Re: Review of Selection and Implementation of Alternatives Report  
Bergen County Utilities Authority (BCUA), NJPDES Permit No. NJ0020028  
Borough of Fort Lee, NJPDES Permit No. NJ0034517  
City of Hackensack, NJPDES Permit No. NJ0108766  
Village of Ridgefield Park, NJPDES Permit No. NJ0109118

Thank you for your submission dated October 1, 2020 entitled “Selection and Implementation of Alternatives Report” for the BCUA, Borough of Fort Lee (Fort Lee), City of Hackensack (Hackensack) and Village of Ridgefield Park (Ridgefield Park) as submitted to the New Jersey Department of Environmental Protection (the Department or NJDEP). This report was submitted in a timely manner and was prepared in accordance with Part IV.D.3.b.vi of the above referenced New Jersey Pollutant Discharge Elimination System (NJPDES) permit. This submission was issued in response to the Long-Term Control Plan (LTCP) submittal requirements as due on October 1, 2020.

The below represents the Department’s initial comments. The Department reserves the right to further comment on these issues. Comments are as follows.

Figure 2-2: Example of the Delineation of the 60 Acre Sewer Separation Area

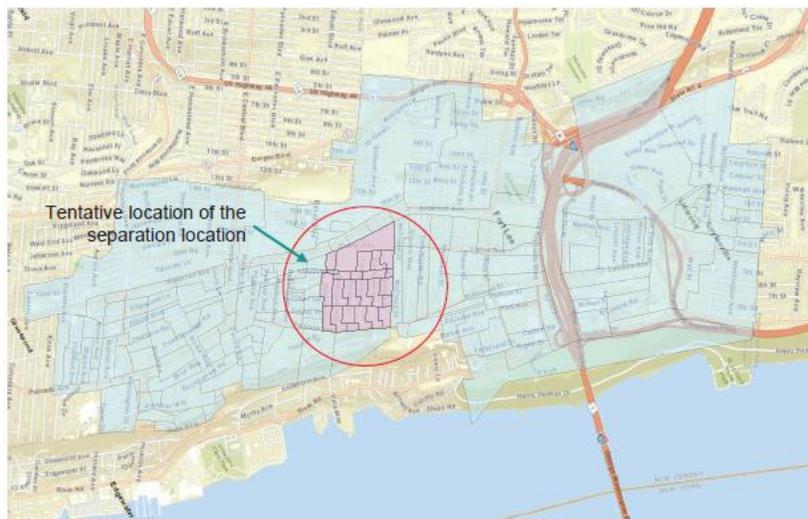
Comment 6: Section 2.2.4 , Operational Plan, Schedule, and Post Construction Compliance Monitoring includes Figure 2-2 namely a map of Fort Lee as follows:

Provide additional information to supplement Figure 2-2:

- a) In order to show the relative effect of sewer separation, revise Figure 2-2 to designate which portions of Fort Lee are currently served by a combined sewer system versus a separate sewer system. In addition, label the location of the existing CSO outfalls.
- b) Expand and revise Figure 2-2 to indicate the locations of the five phases of sewer separation.
- c) Figure 2-2 states "Tentative location of the separation location" and is labeled "Example of the Delineation of the 60 Acre sewer Separation Area." Given that this is an LTCP, it must include the selected alternatives and not indicate tentative locations. The Department is concerned that there is not a firm plan or commitment to sewer separation given these labeling designations. Please explain.
